**Dogger Bank South Offshore
Wind Farms**

**The Applicants' Responses to April 2025 Hearing
Action Points**

Document Date: April 2025

Document Reference: 14.11

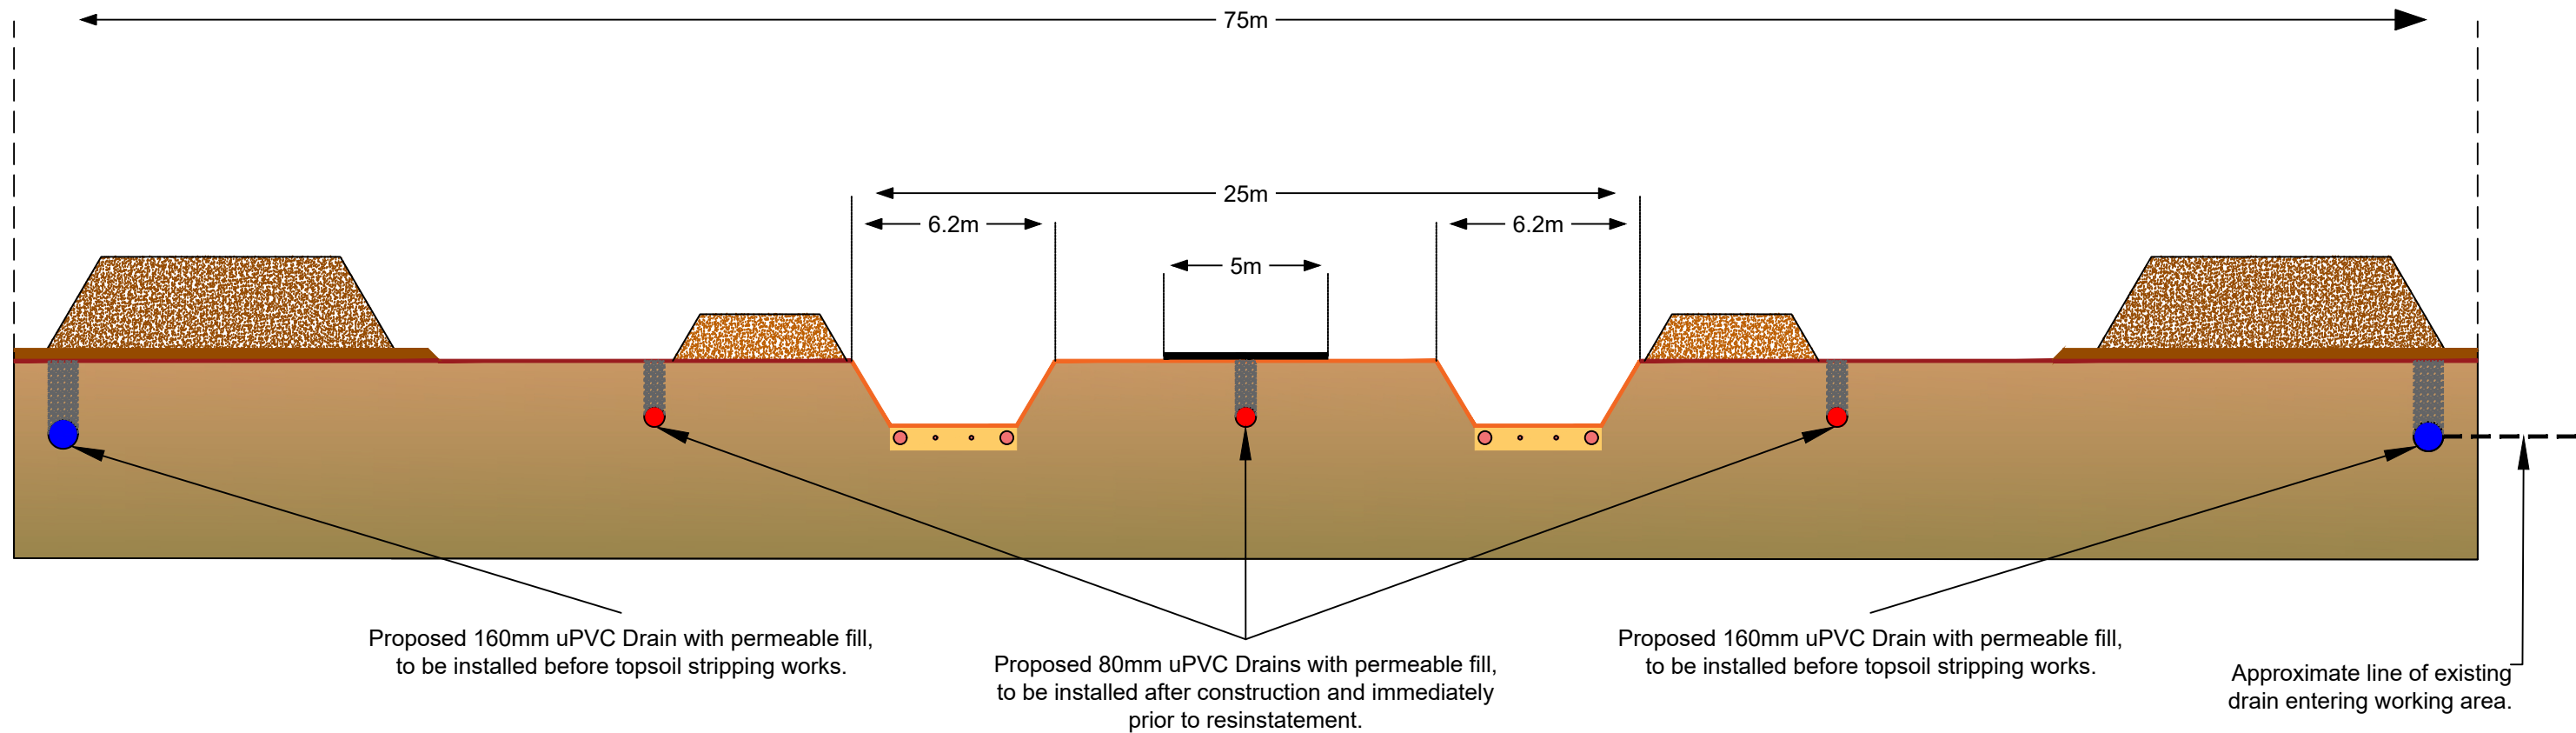
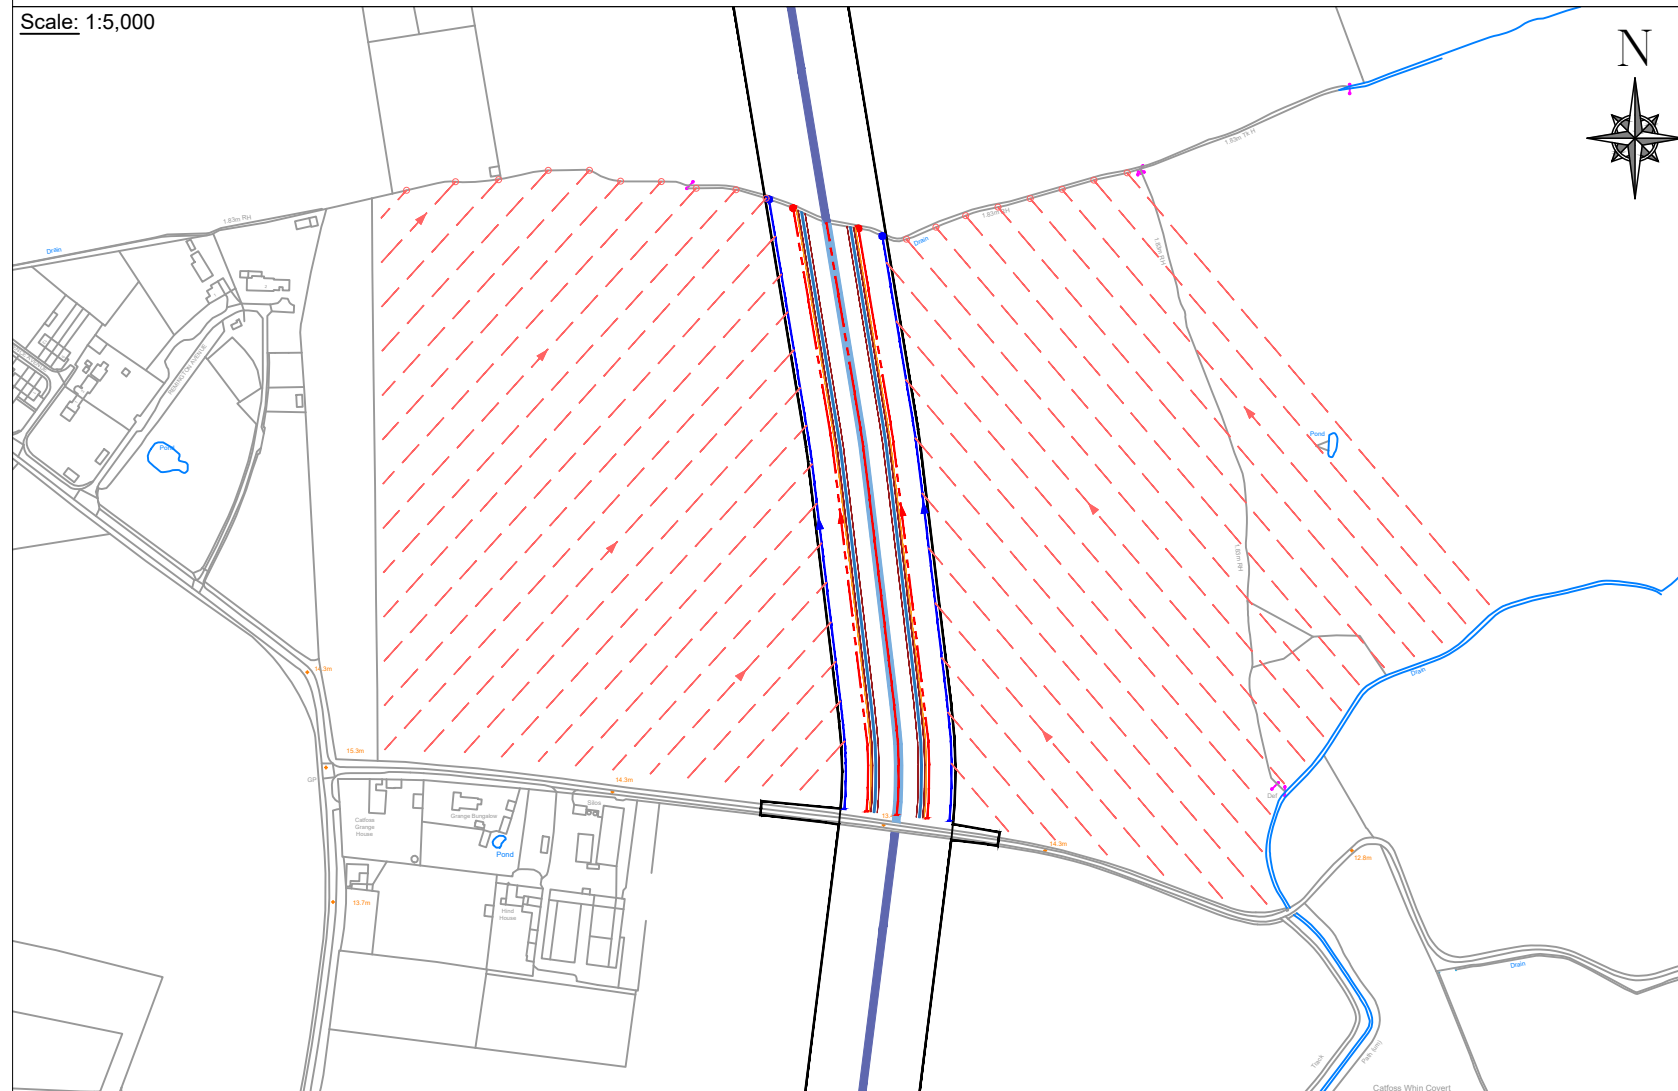
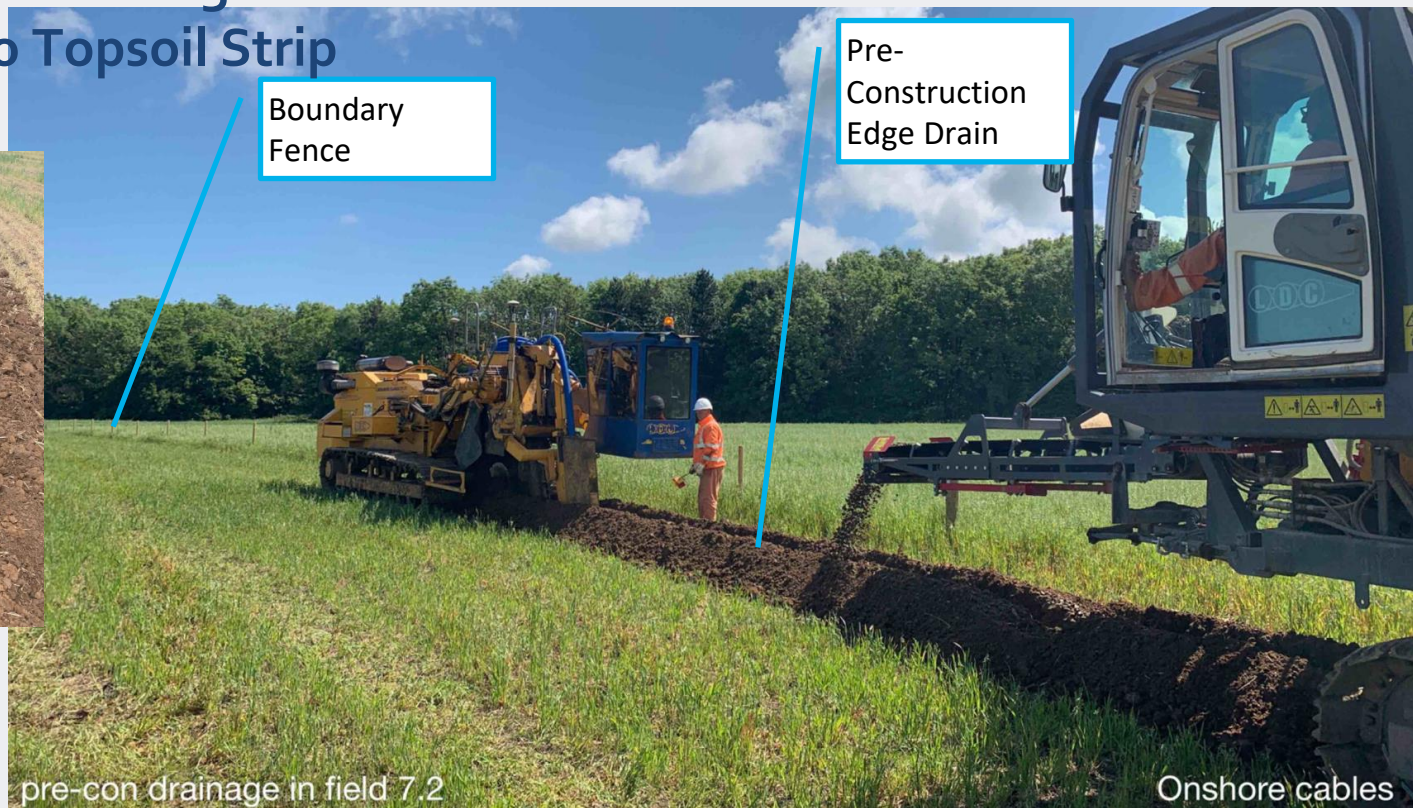
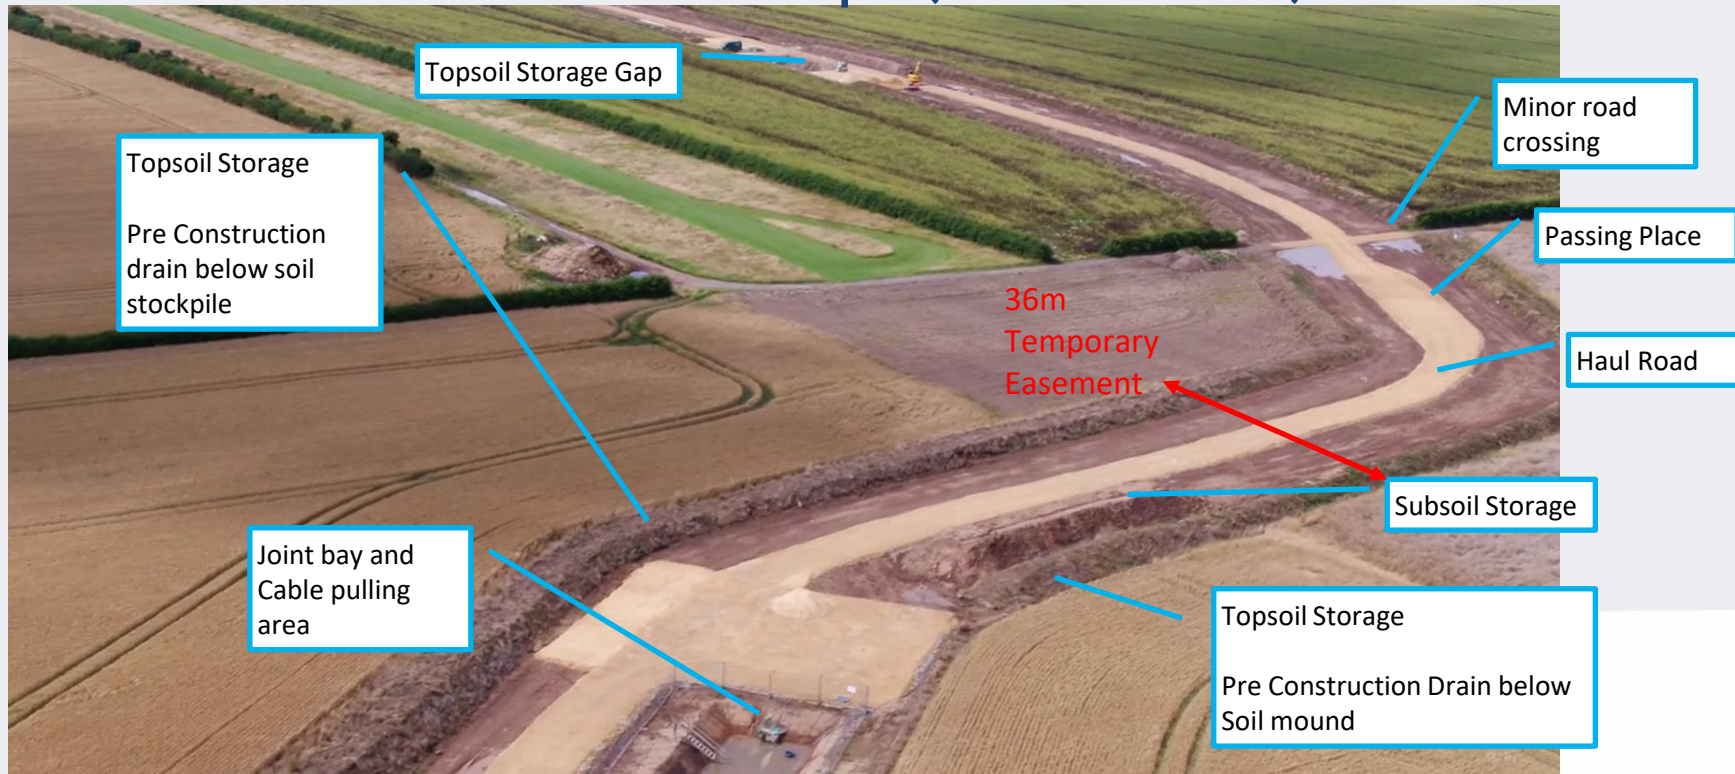
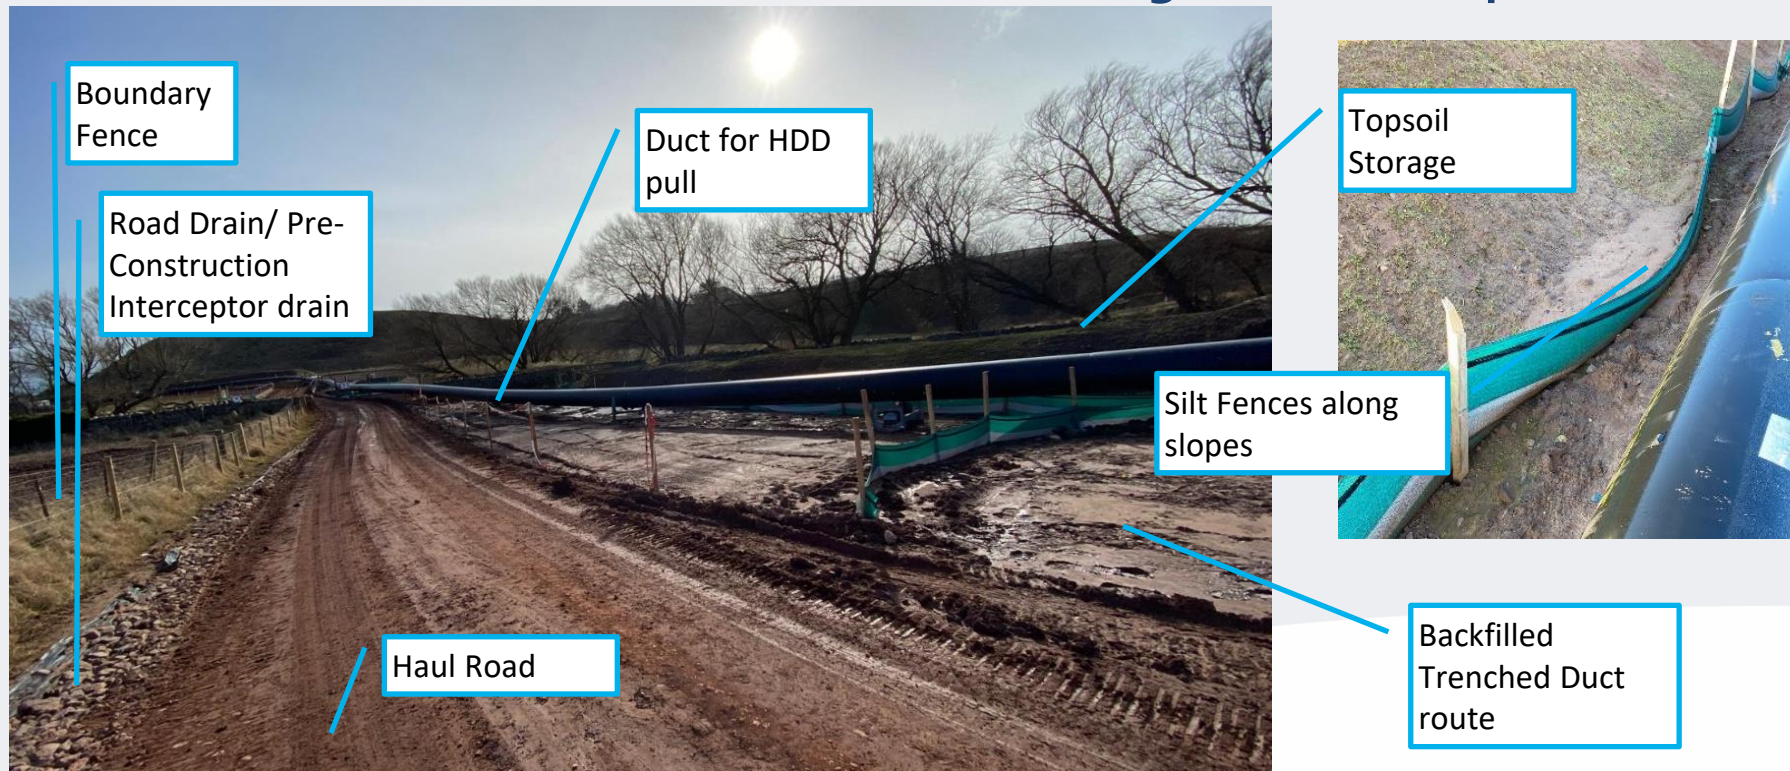
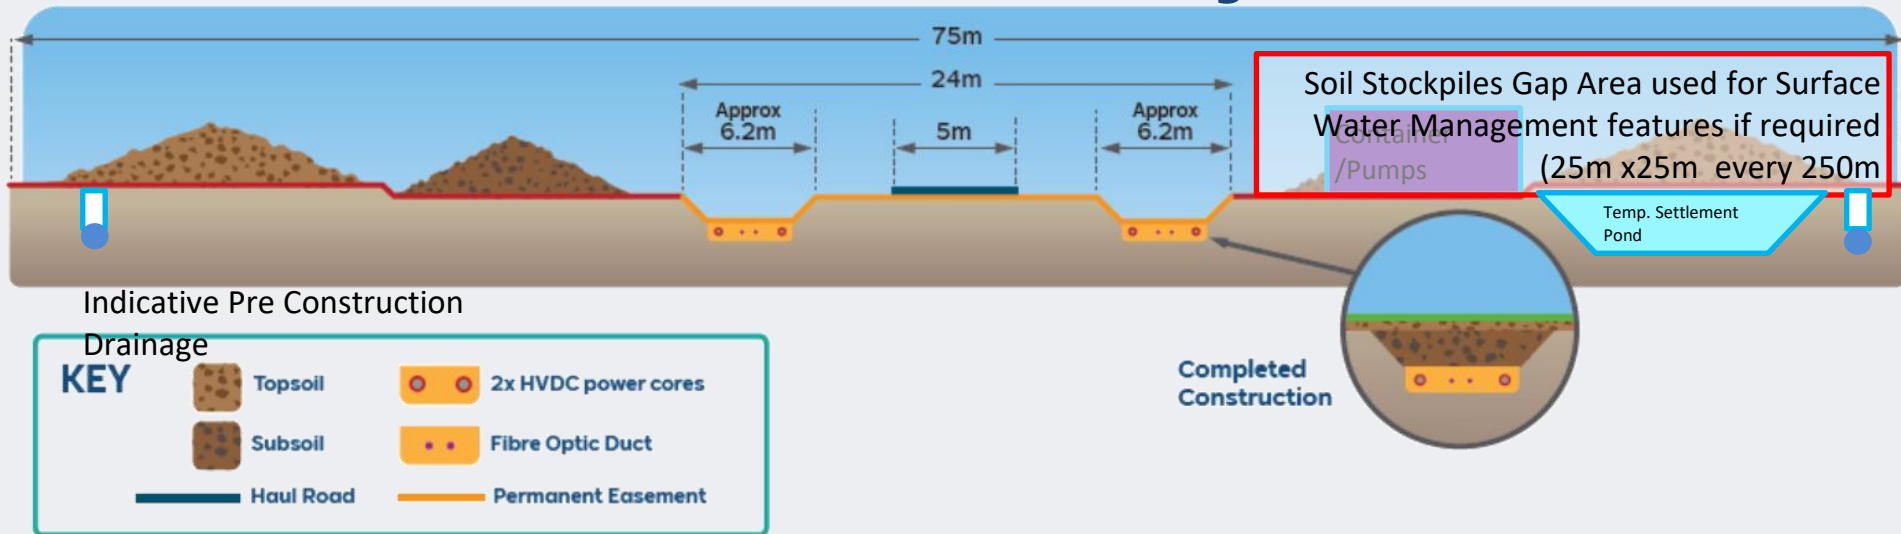
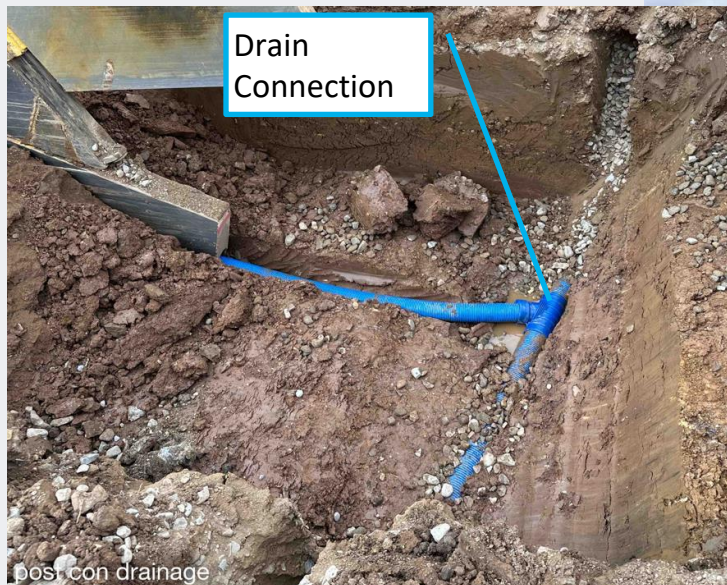
13	<p>Provide evidence how the proposed mitigation features which manage overland flow, existing agricultural drainage, runoff from the proposed development and pollution control could be accommodated within the order limits for the export cable corridor. The ExA is uncertain of the number of features, their scale and location. For example, could an indicative cross section/ figure to illustrate this may, be provided in part, help to evidence this.</p>	<p>There are two elements of the drainage design along the Onshore Export Cable Corridor. The first is the 'land drainage design' put in place prior to construction to intercept existing agricultural drains and to keep the working areas dry during construction. This is described as 'pre and post construction' land drainage in the Outline Drainage Strategy (Revision 3) [REP2-033] as detailed in section 1.2. All land drains installed are permanent features The Applicants have taken the issue of potential impacts on existing land drainage very seriously, given the majority of land within the Order Limits is agricultural and has existing land drainage systems in place. All land drains installed are permanent features. The Applicants have taken the issue of potential impacts on existing land drainage very seriously, given the majority of land within the Order Limits is agricultural and has existing land drainage systems in place. Therefore, the Applicants have already engaged a specialist land drainage consultant, to undertake drainage surveys and develop conceptual drainage designs for agreement with individual land owners. These will be used by the Contractor to develop the detailed drainage design, post consent. The Applicants can confirm that they do not have the right to install the drainage infrastructure outside of the Order Limits. Land Drainage Consultancy (LDC), the Applicants' specialist land drainage contractor, have provided further details on a 'typical' land drainage system for the Projects to demonstrate how it could fit within the Projects' Order Limits in Appendix B. This design is indicative but based on the ongoing work with landowners to develop a conceptual drainage design and includes an indicative cross section.</p> <p>The other element of the construction drainage design along the Onshore Export Cable Corridor is controlled by the Surface Water Management Plan (SWMP), which will be developed by the Contractor at the detailed design stage. As detailed in Section 6.3.2.4 of the OCoCP (Revision 4) [document reference:8.9] which is secured by Requirement 19 of the Draft DCO (Revision 7) [document reference: 3.1]. This is approved by the East Riding of Yorkshire Council, prior to construction. This will include measures for surface water run-off from within the Order Limits and any ground water which is not intercepted by the land drainage design and may enter excavations for the cable trenches. As discussed in the ISH4 there may be situations where water needs to be pumped out from excavations, this will be dependent on several site specific variables including: local topography, soil type, the season the work is being undertaken and the location of suitable discharge points.</p> <p>As described by the Applicants' civil engineer at ISH 4 the Order limits have been calculated to allow flexibility in design of the Onshore Export Cable Corridor, based on experience from previous projects including Triton Knoll (works completed) and Sofia (Dogger Bank C) (cables installed and reinstatement in progress). As noted in GGC 1.6, soil volumes have been analysed including an allowance for 10m gaps in the stock piles every 100m and would allow</p>

Action No.	Action	Applicants' Response
		<p>room for localised surface water management measures, where required. Soil storage can be reconfigured to provide larger areas adjacent to the cable route, or other work sequencing to reduce surface water risks.</p> <p>Some examples of control measures include adding silt fences on a sloping site, the excavation of sumps to collect water at suitable locations based on gradient and selecting suitably sized pumps to discharge water at the rate agreed and specified with the relevant drainage authority. This would also include measures to avoid fines entering the water course. If there is a requirement for discharge of collected run-off or dewatering of excavations, water will be pumped out and passed through a suitable filtration system which may include a settlement tank or lagoon to allow suspended solids to settle out before being discharged to an appropriate location. Appropriate treatment methods will be adopted prior to discharge of the water from any land drains uncovered during the construction phase.</p> <p>The SWMP will be bespoke to the section and phase of construction works along the site and it will be the responsibility of the Contactor to ensure that the measures implemented both fit within the Order Limits and stop surface water running off the site into neighbouring land. This is standard practice in long linear developments and further detail will be provided post consent when the Contractor is on board, which the Applicants do not yet have in place to advise further. Some photos of sites where active surface water management is taking place along the Onshore Export Cable Corridor are included in Appendix C.</p>

Attached to this letter is an indicative cross-section diagram showing a generic site layout. We have also included a plan view for clarity.

Additional area can be made available through relocating Soil Storage away from the work area, if required.
